# WP-25-26

Wetlands Permitting

Re: 25-26W – 29 Shore Drive

Review Memorandum

CZAIKOWSKI FAMILY  
 29 SHORE DRIVE  
 COVENTRY CT  
 PROPOSED PARKING WALK  
 AND PATIO  
 DRAWN BY JAMES BAIR  
 9-10-2025 1"=20'

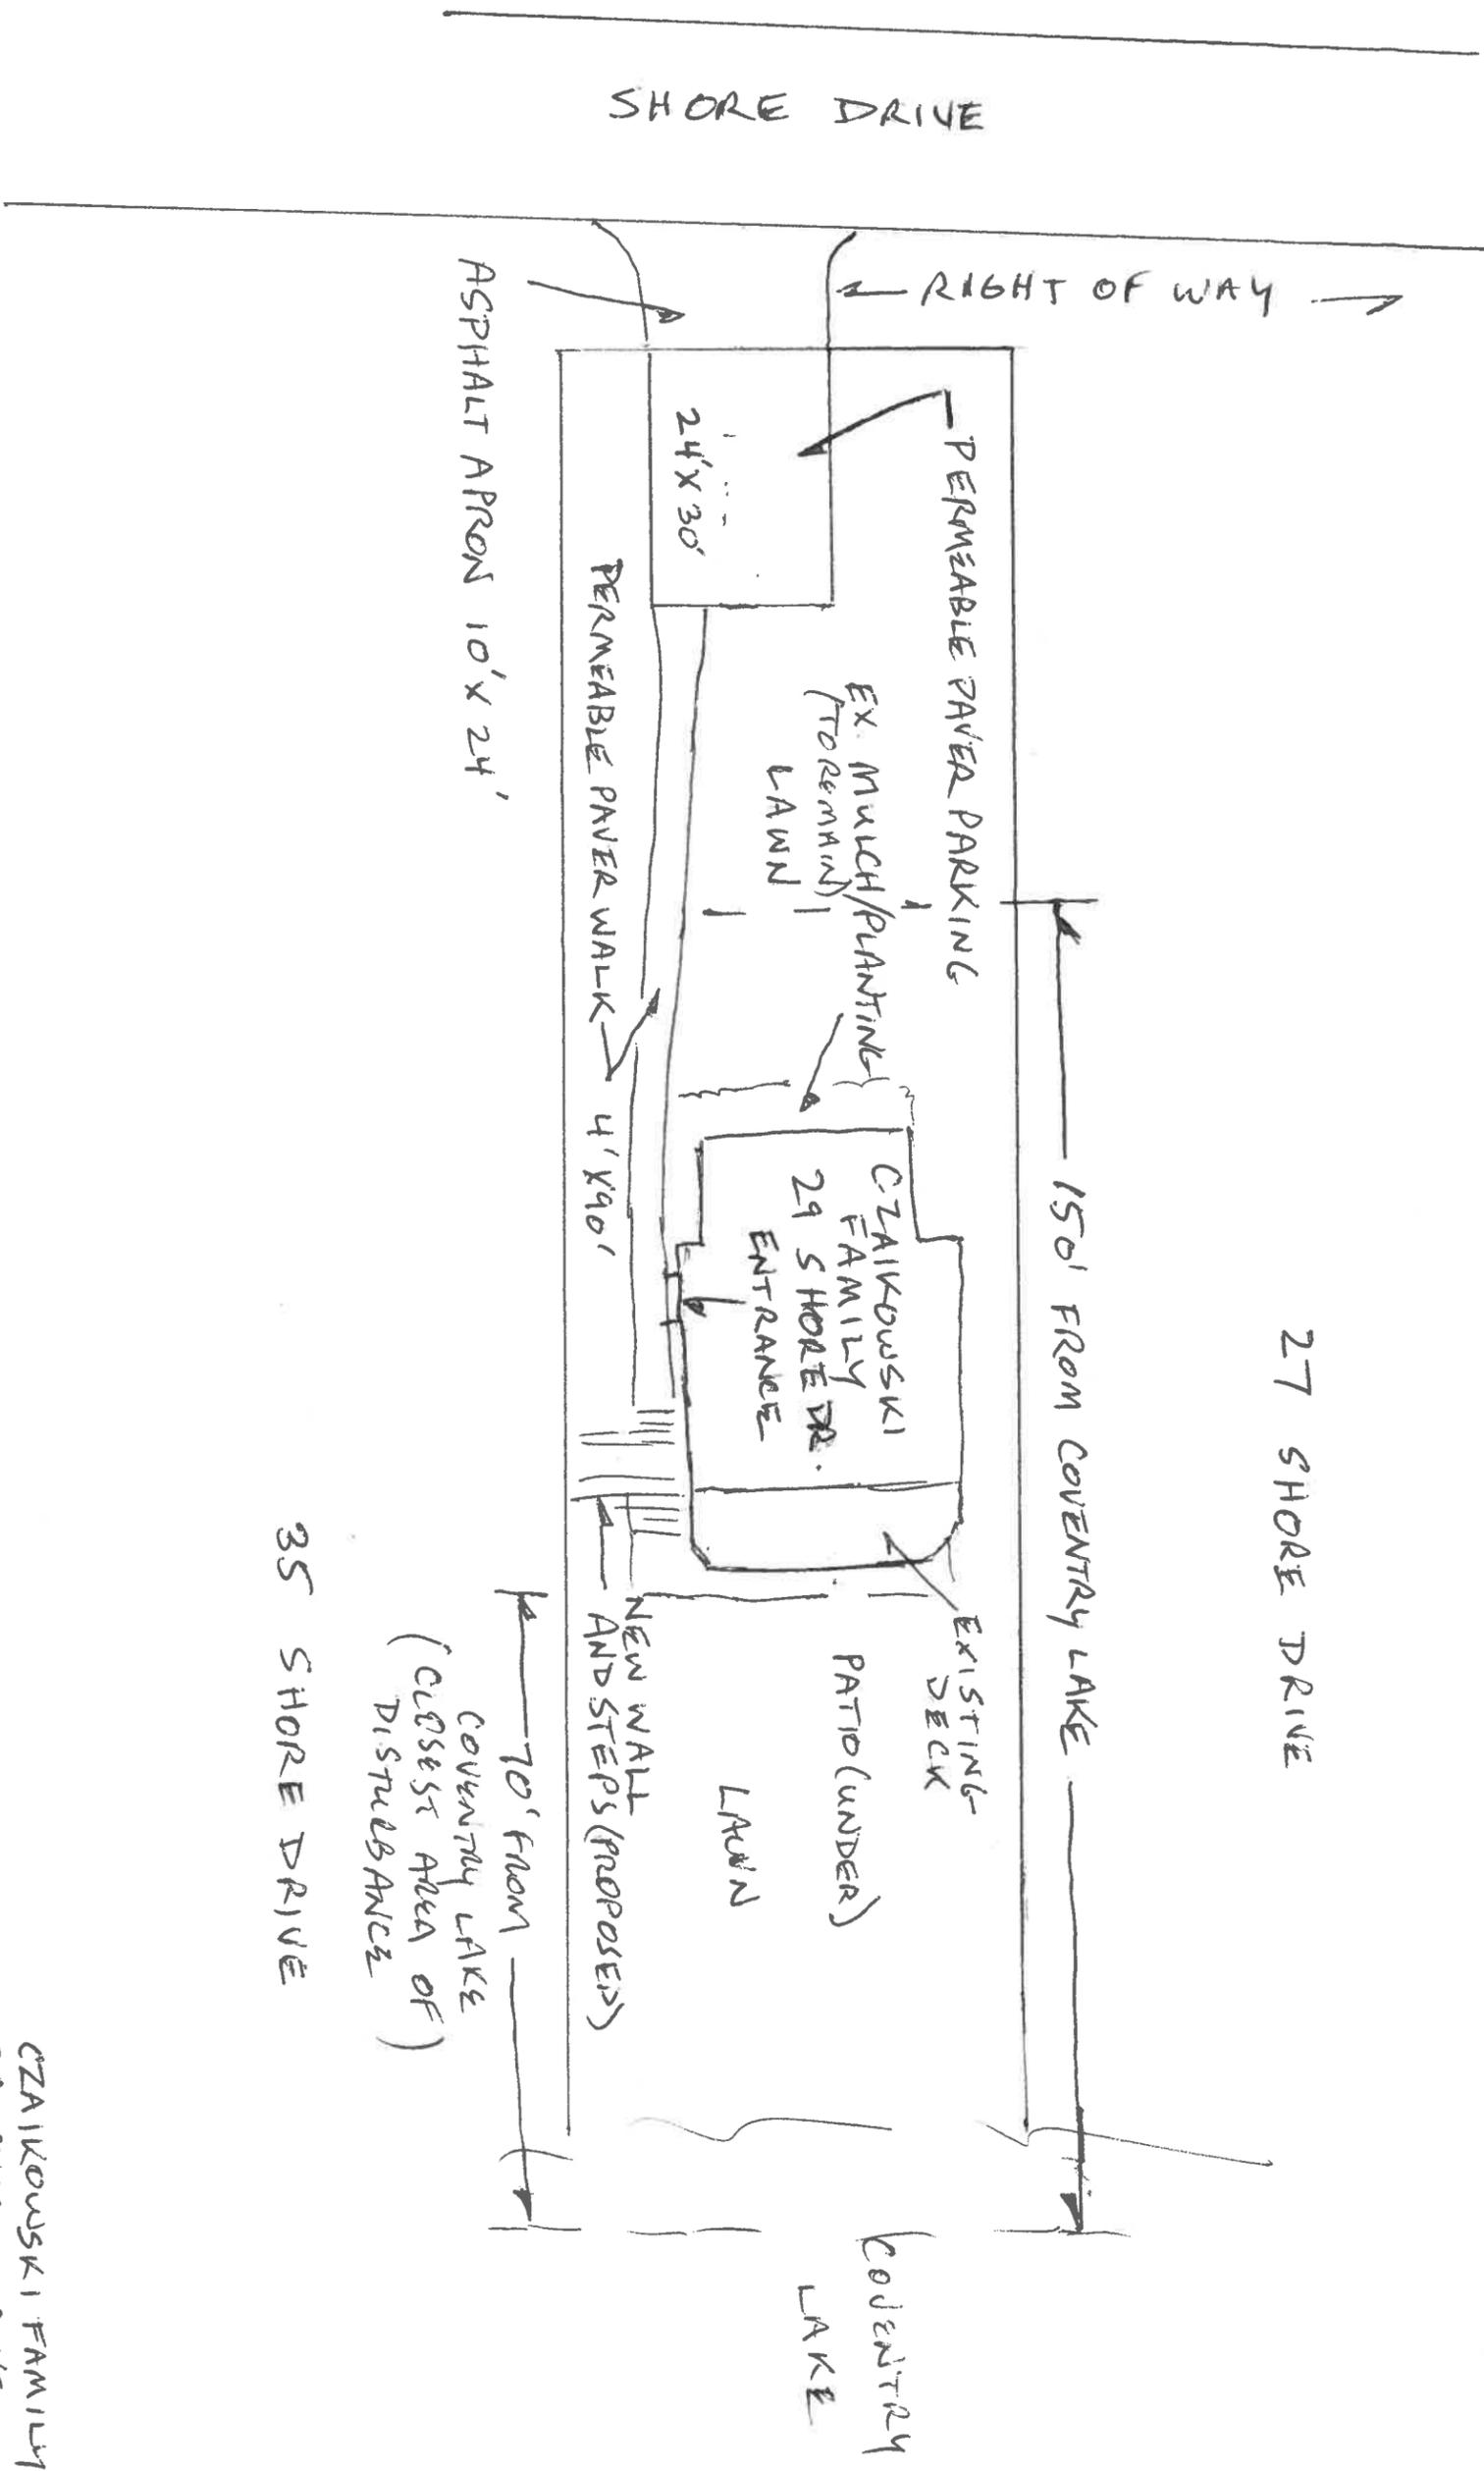
- Depict the 150-foot upland review area on site plan to show which proposed activities are regulated.
- The area of disturbance on the application identifies the proposed activity will result in 2,000sqft of upland review area disturbance. Confirm and/or recalculate the proposed upland review area disturbance with the 150-foot upland review area on the site plan. Revise the application accordingly.

- Provide a measurement from Coventry Lake and closest proposed ground disturbance.
- Revise project narrative to match dimensions of permeable parking area on site plan and add an arrow pointing to parking area.
